Clerk's Contract and Agreement Cover Page

Contract Description: Main Pumping Station - East Reservoir Addition

CONTRACT CHANGE ORDER NO. 1

OWNER: Village of Orland Park, Illinois
 CONTRACTOR: Joseph J. Henderson & Son, Inc.
 P.O. Box 9
 Gurnee, IL 60031
 CONTRACT: East Reservoir Addition

FILE NAME	14601-S2
DWG	S2
SHEET	6 OF 9
DATE	MARCH 2008
REV	0

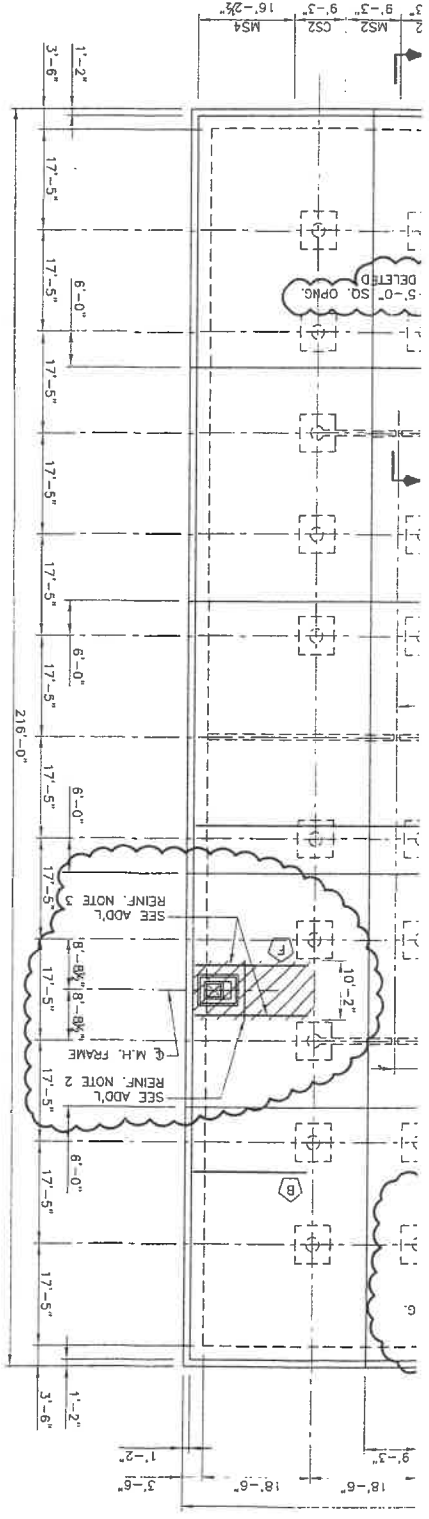
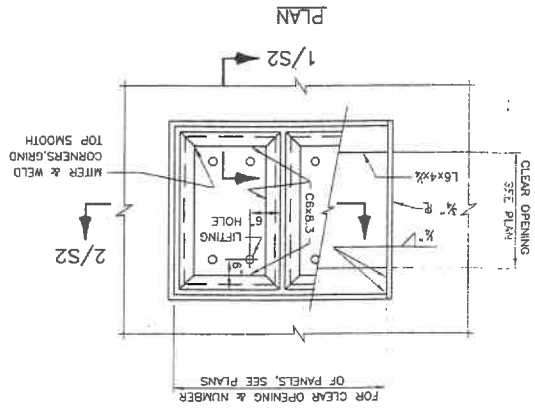
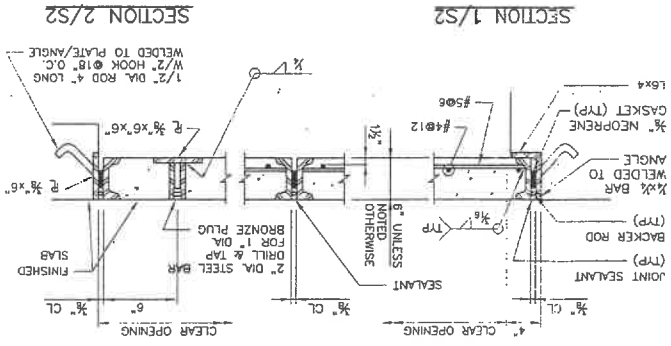
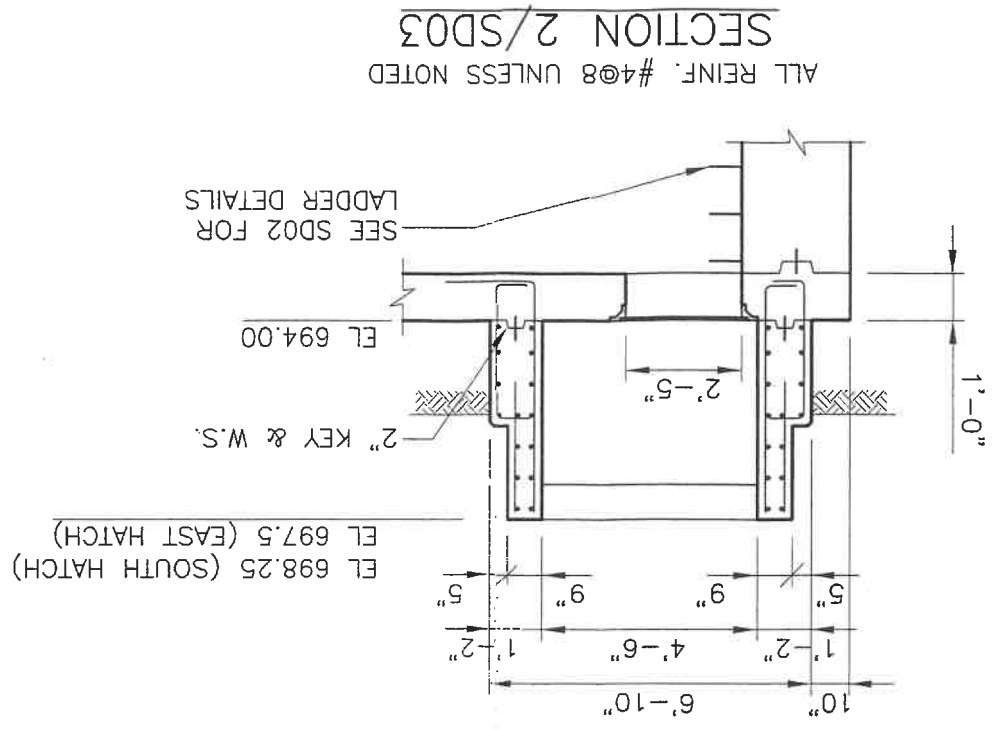
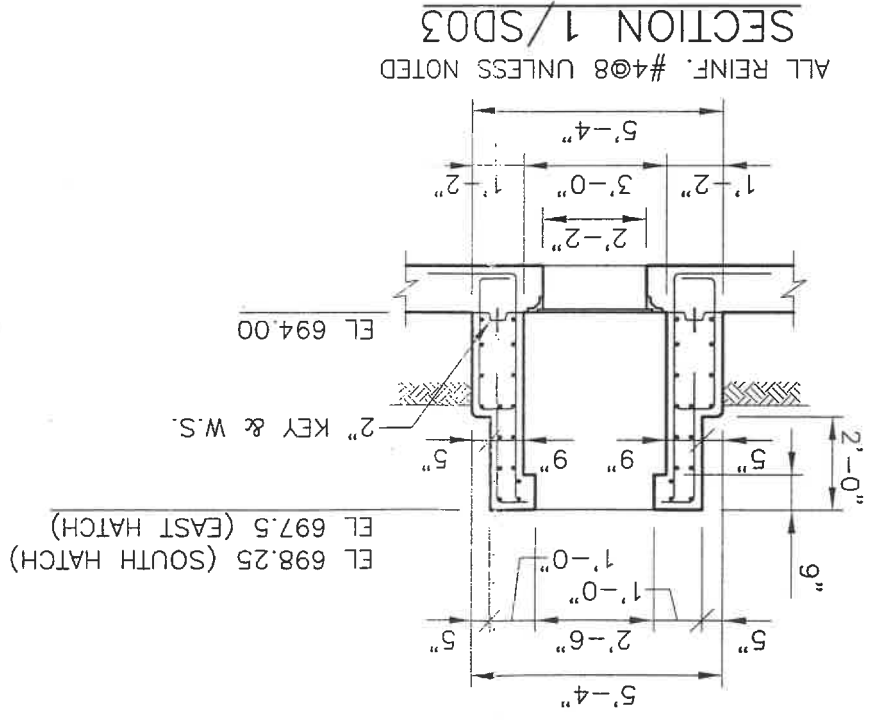
The revisions to Drawing S2 that are bubbled answers the locations questions and SD03 gives the orientation.

1. WILL THE NEW CASTING IN "C" BE PLACED AT THE SAME LOCATION AS THE 36" DIA. ONE SHOWN NOW? THE CENTER LINE WILL BE 9'-3" FROM EACH COLLINE AND PLACED TO CLEAR THE WALL BELOW
Answer: Yes the new casting is in the same location as the original 36" diameter casting was going to be 9'3" from each column line. See revised drawing S2. Yes, the opening, which is actually 26" x 29" clear access needs to clear the wall below.

2. WHERE WILL THE OTHER CASTING IN "P" BE LOCATED?
Answer: The new casting in P is 8'-8.5" from each column line and needs to clear the wall below. See revised drawing S2.

3. WE WILL DELETE THE TWO LIFT-OUT SLABS IN "B" AND "V";
Answer: Yes the two 5'-0" removable slabs in B and V are being eliminated. The only removable slab remaining is in slab O.

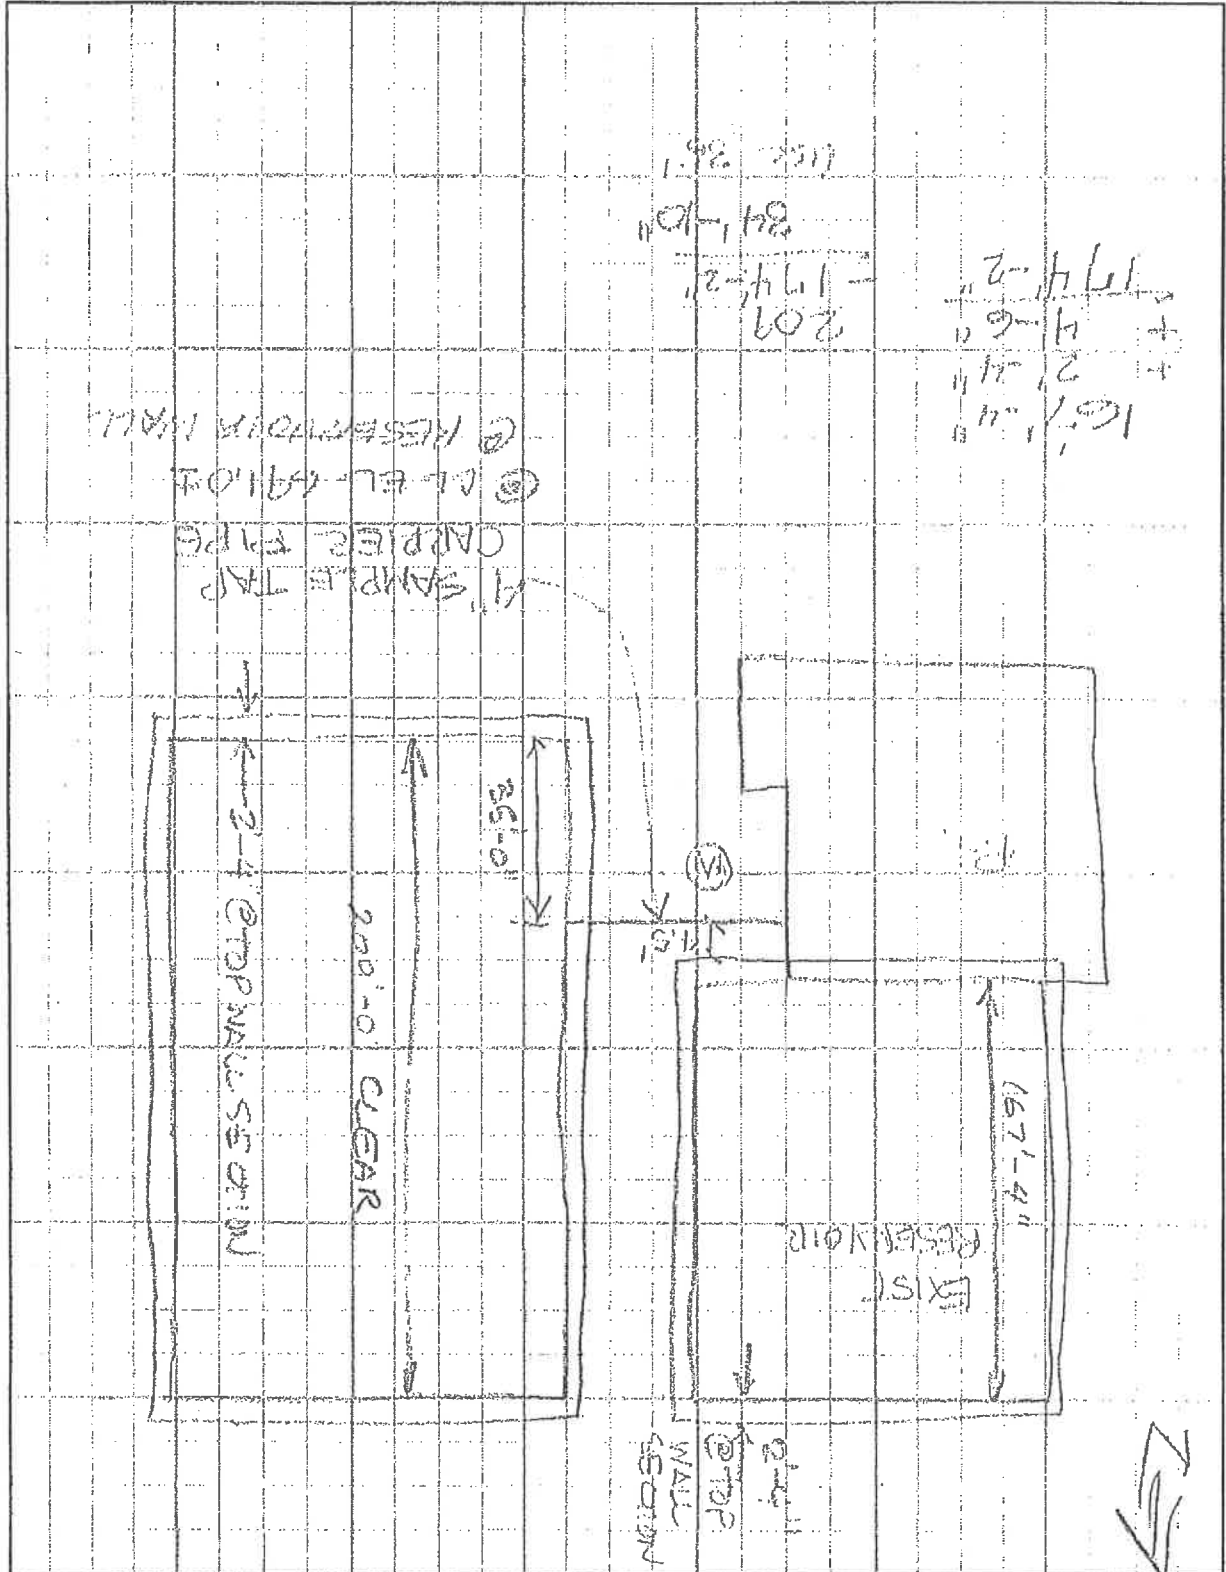
Based on information from Frank, he will get a 8 foot section of F x PE DI pipe and weld on a water collar. As he can't get it drill and tapped for studs in time to maintain schedule, the flange end will need to extend approximately 6" into the reservoir so that a tapped blind flange can be added later. Later the outside end of the pipe will be cut for a MJ joint within 2-3 feet of the exterior of the reservoir wall. It is my understanding that this can be done to stay on schedule for the Friday pour of the reservoir upper wall at slab E.

To use this approach, JH will have to cut holes into the forms. I have discussed this with Mike and he is prepared to do it rather than waiting to get a tapped flange. I have indicated to Mike that the exact elevation can be varied to avoid the rebar grid.

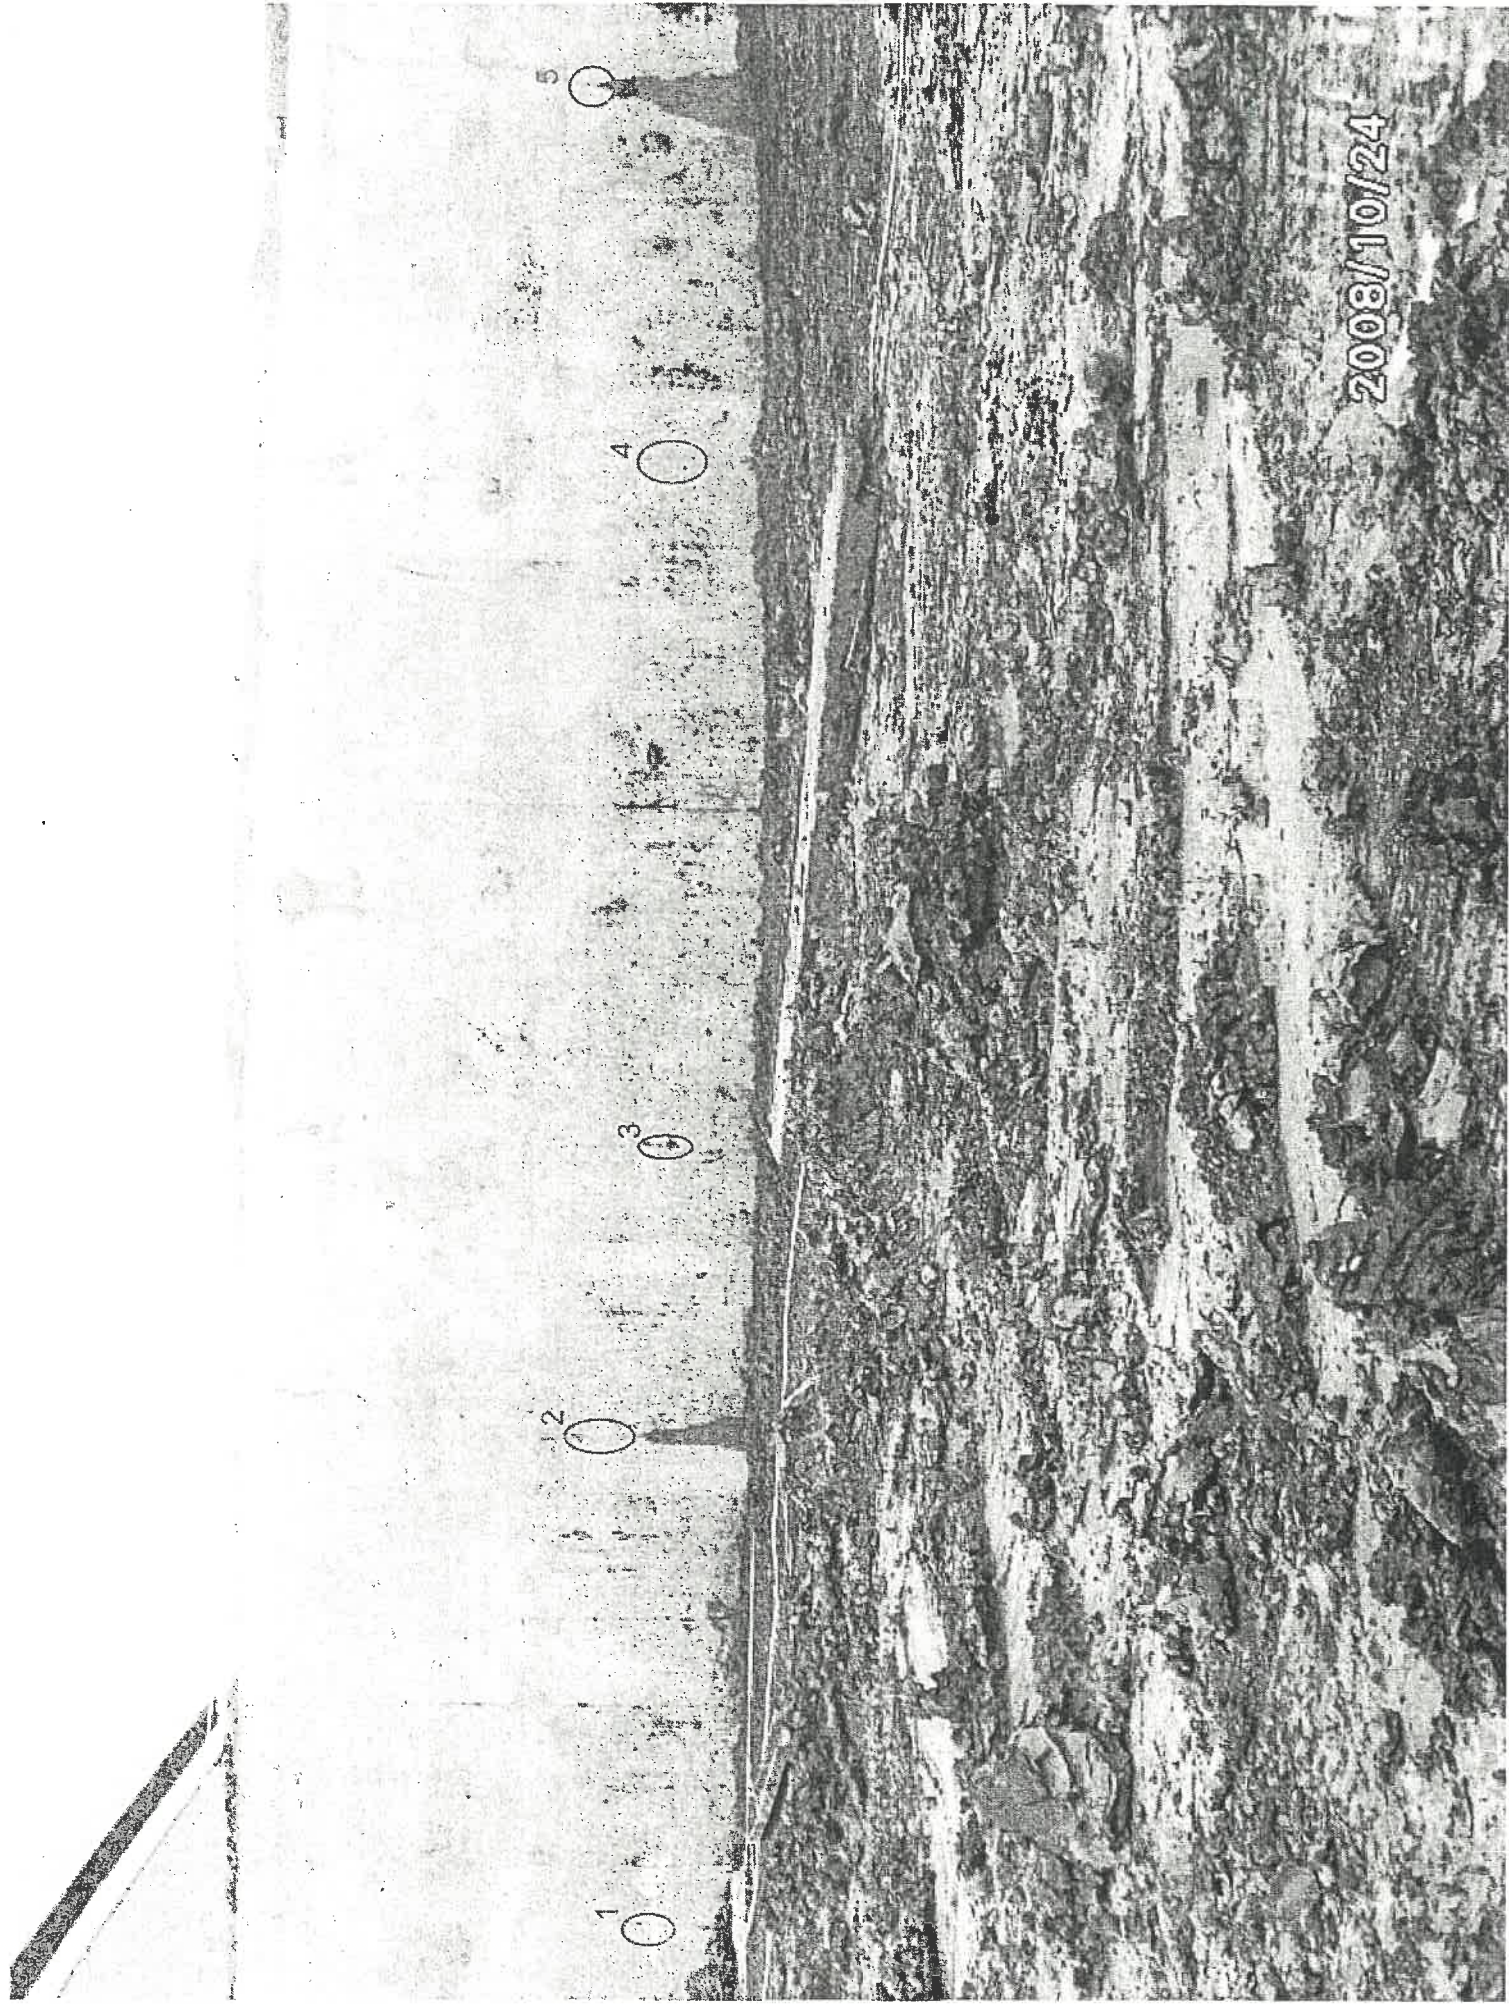
Please provide a change order proposal to perform crack sealing on cracks having opening larger than 10 mil (0.01") in the existing reservoir using the Sikaflex -1a or a Hydrophilic Polyurethane Flexible Injection GROUT such as the Wflexgel2, for which the information is attached. The email below and attached pictures identify the locations for the cracks to be repaired. Also, there are some form tie ends in the existing reservoir that are rusted. Please indicate the change order cost to , clean and paint these ends with a rust inhibitor paint.

Provide all labor, material and equipment necessary to seal those cracks specifically listed in Ray David's e-mail of 4-30-09.

SUPPLEMENTARY
 DRAWING
SD03

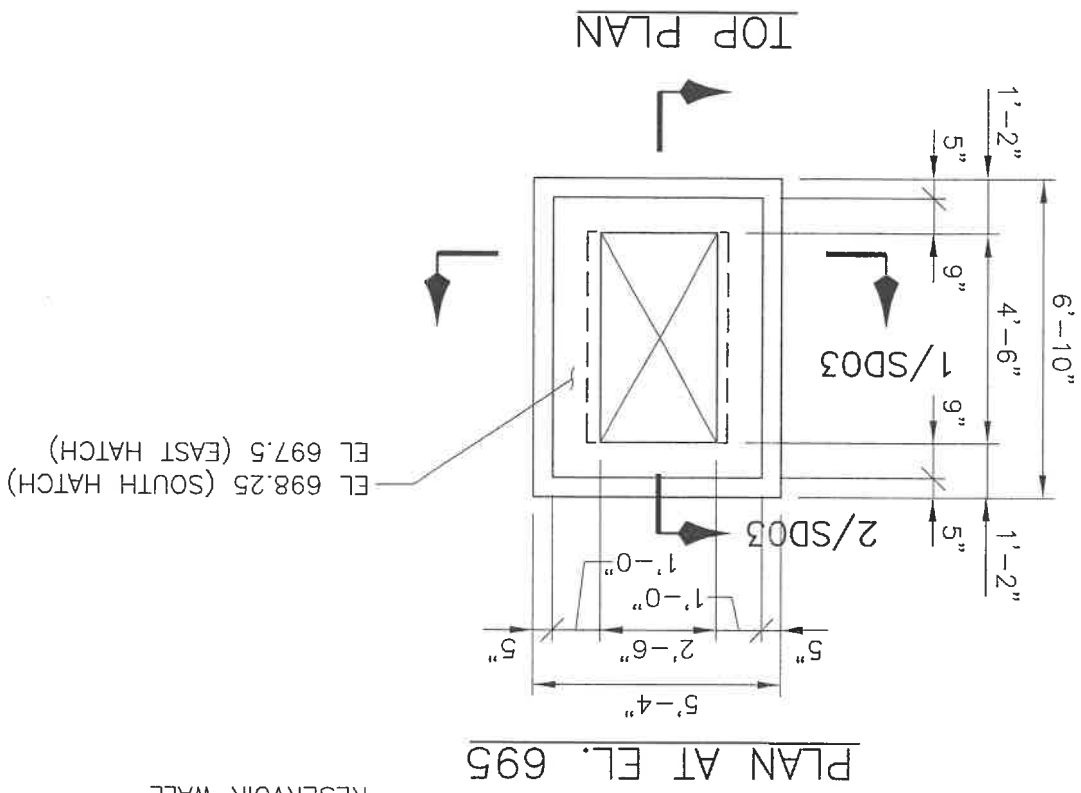
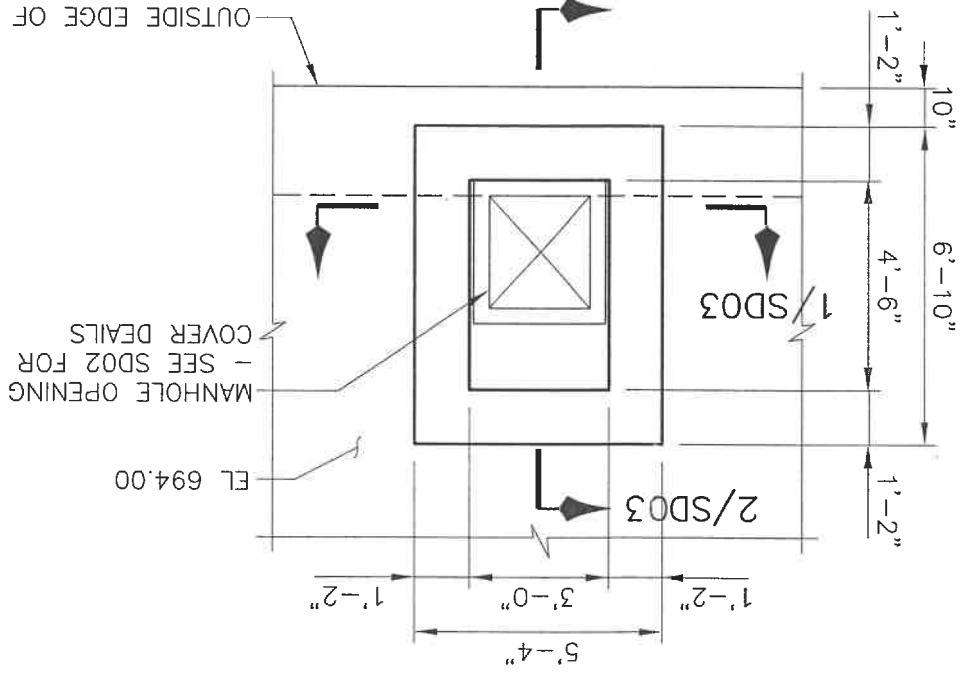
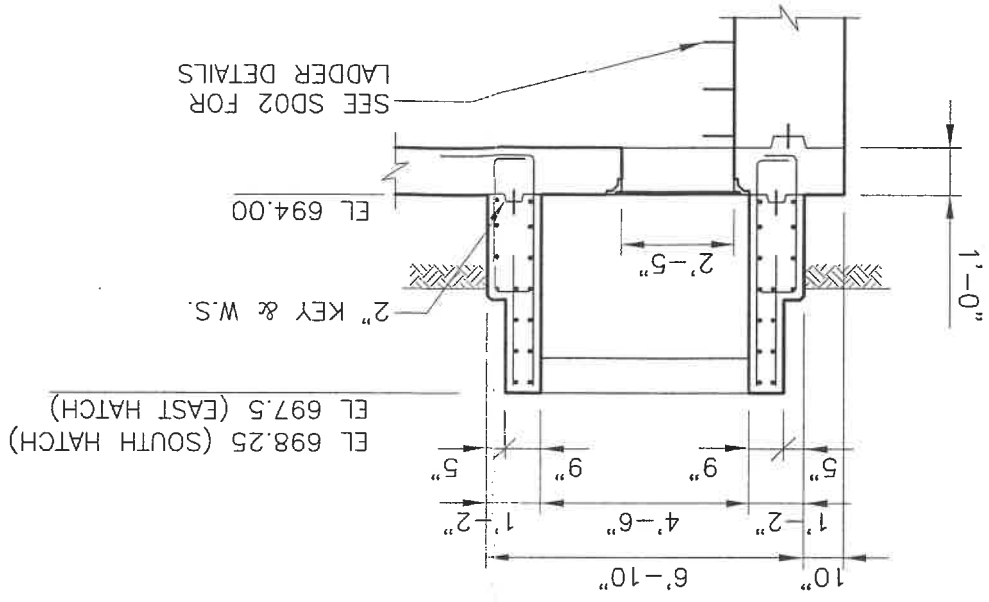
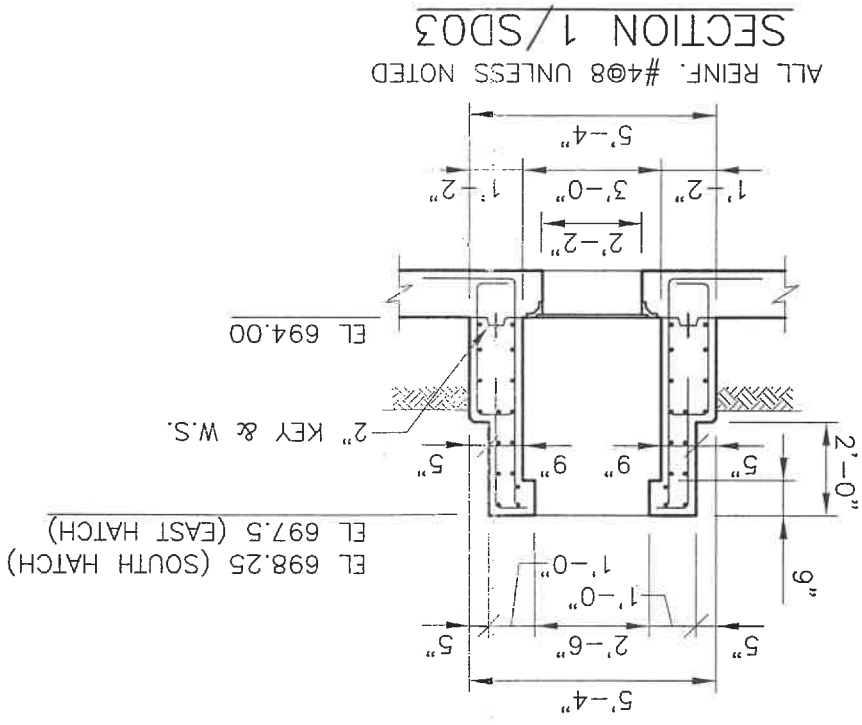
3. In order to obtain a permit to construct and operate, the Illinois Environmental Protection Agency required modifications to the project design including: addition of two access locations to the new East Reservoir Addition with above grade hatches and associated pump shelf, and associated electrical work. The two access hatches in the top slab replaced two of the three concrete slab openings, and were tied into the Main Pump Station Alarm System. The sampling pump was installed inside the Main Pump Station and sample line installed connecting the sampling pump to the new East Reservoir Addition to provide the Owner the ability to sample the water in the new East Reservoir. These modifications were added following acceptance of bids for the project. At the request of the Engineer and the Owner, JJH performed the requested work, which is documented in the Extra Work Order dated July 1, 2009. This work results in an increase in the Contract Price of\$51,944.87

Answer: The short side of the casting is parallel to the outside wall of the reservoir. The actual clear dimensions of the access opening are actually 26 x 29. This is shown in drawing SD03 in the section 2/SD03 where the 29" dimension is perpendicular to the outside wall. Thus, for the casting in slab C, the short side is east-west running and for slab P the short side is north-south running.

I have attached the revised drawings S2, SD03 and the casting cut sheet to this email. Let me know if you have further questions. It is great news that the castings will be coming soon and that the top slabs work is proceeding.
